## COUNCIL ASSESSMENT REPORT

### HUNTER AND CENTRAL COAST REGIONAL PLANNING PANEL

<b>Panel Reference</b>	PPSHCC-382
<b>DA Number</b>	DA/2024/763:1
<b>LGA</b>	Maitland City Council
<b>Proposed Development</b>	Section 8.2 Review of Determination - Concept Development Application for Two (2) into 900 Lot Staged Torrens Title Subdivision with Stage 1 Torrens Title Subdivision of 226 Lots
<b>Street Address</b>	Lot: 177 DP874171, Lot: 55 DP874170  559 Anambah Road, GOSFORTH NSW 2320
<b>Applicant</b>	The Trustee for Third.i Anambah Unit Trust
<b>Date of DA lodgement</b>	4 November 2025
<b>Total number of Submissions Number of Unique Objections and Summary of key submissions</b>	A total of seventeen (17) unique submissions were received to the development. The development was notified on: 13 November 2025 to 10 December 2025.  Key Issues: <ul style="list-style-type: none"> <li>• Sequencing and orderly development;</li> <li>• Traffic impacts and road safety;</li> <li>• Flooding, isolation and reliability of access;</li> <li>• Use of River Road (safety, rural character, infrastructure constraints);</li> <li>• Utilities and servicing constraints (water, sewer, schools, public transport);</l

*Figure 19: An excerpt from the Concept Masterplan showing the oversized lot created to facilitate avoidance of the barn owl roosting tree*

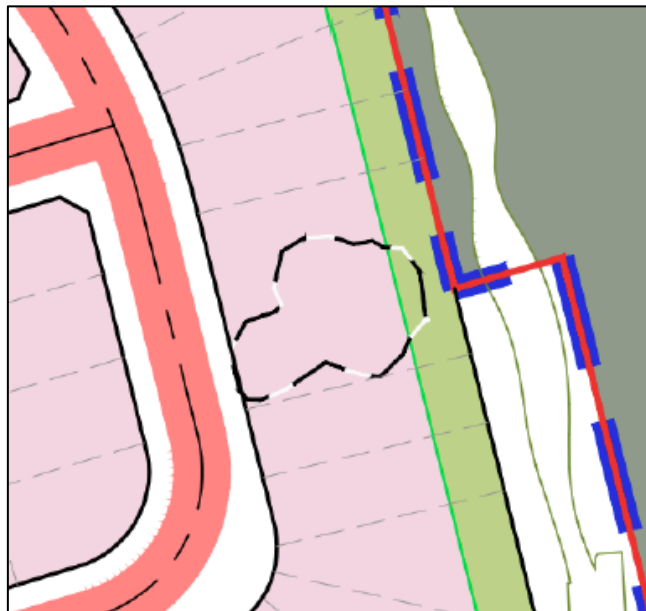
In the Section 8.2 Review, the applicant asserts further avoidance. The Concept Masterplan indicates that an oversized residential allotment has been created to facilitate retention of the barn owl roosting tree (see **Figure 19** below); however, this retention is not reflected in the updated Landscape Plan or updated Civil plans.

Amendments to the Landscape Plan, BDAR and arborist assessment would be required to confirm that the long-term protection of this vegetation is feasible and appropriately secured.

Any additional vegetation avoidance measures claimed by the applicant are not shown on either the Concept Masterplan or the Landscape Plan. Further, no updated BDAR or arborist assessment has been provided. Accordingly, the additional avoidance measures claimed by the applicant cannot be substantiated.

**Figure 22 – Engineer cross sections of River Road works (MC02)**

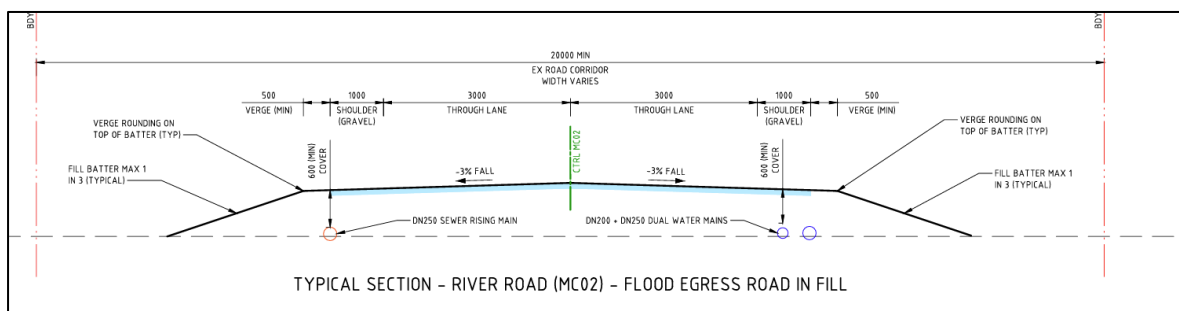
Further concerns arise from the proposal to place major water and sewer infrastructure within the River Road corridor (refer to extract of plans in **Figure 22**). River Road does not meet Council's minimum width, structural or formation standards and is not intended to function as a long-term utility corridor. Installing critical infrastructure within an undersized and ultimately transitional road reserve exposes future development and public authorities to avoidable risks. Any future widening, upgrading or realignment of River Road as the URA progresses would likely require relocation of these assets, creating unnecessary cost, service disruption and delays to broader precinct development.

Given the absence of any endorsed servicing strategy and the limited scope of the available Hunter Water correspondence, the Section 8.2 review does not demonstrate that essential services can be provided in a manner consistent with Clause 6.2 of the MLEP 2011.

In the absence of an updated Notice of Arrangements and an endorsed Servicing Strategy that demonstrates infrastructure certainty, coordinated staging and long-term feasibility, the consent authority cannot be satisfied that adequate arrangements have been made to provide essential water and sewer services as required under Clause 6.2 of the MLEP 2011. Servicing remains a determinative constraint and recommended reason for refusal.

Figure 24 - Todoroski Air Sciences 2.0 OU contour

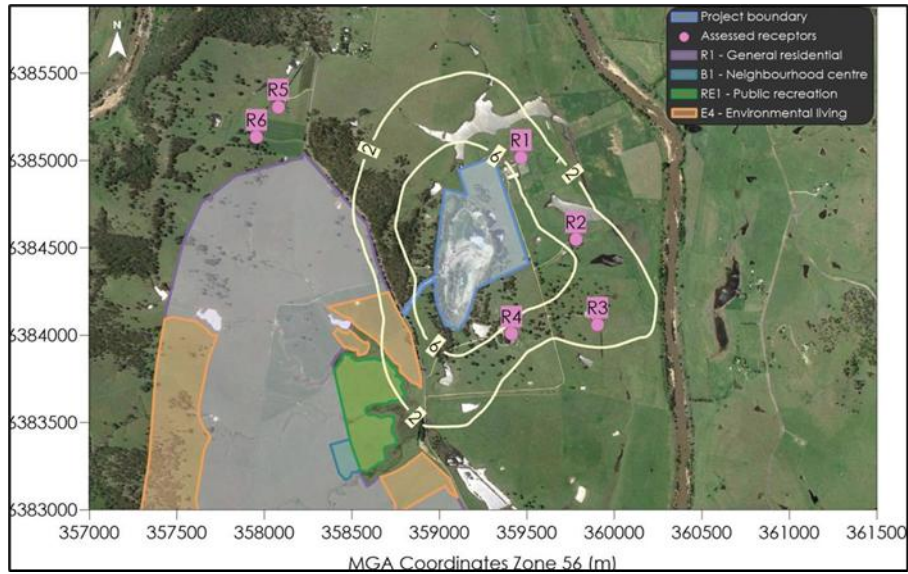
A review of the approved odour contours demonstrates that the 2.0 OU contour extends into the Anambah URA and overlaps with parts of the subject development site, including land within the proposed Stage 1 subdivision area.
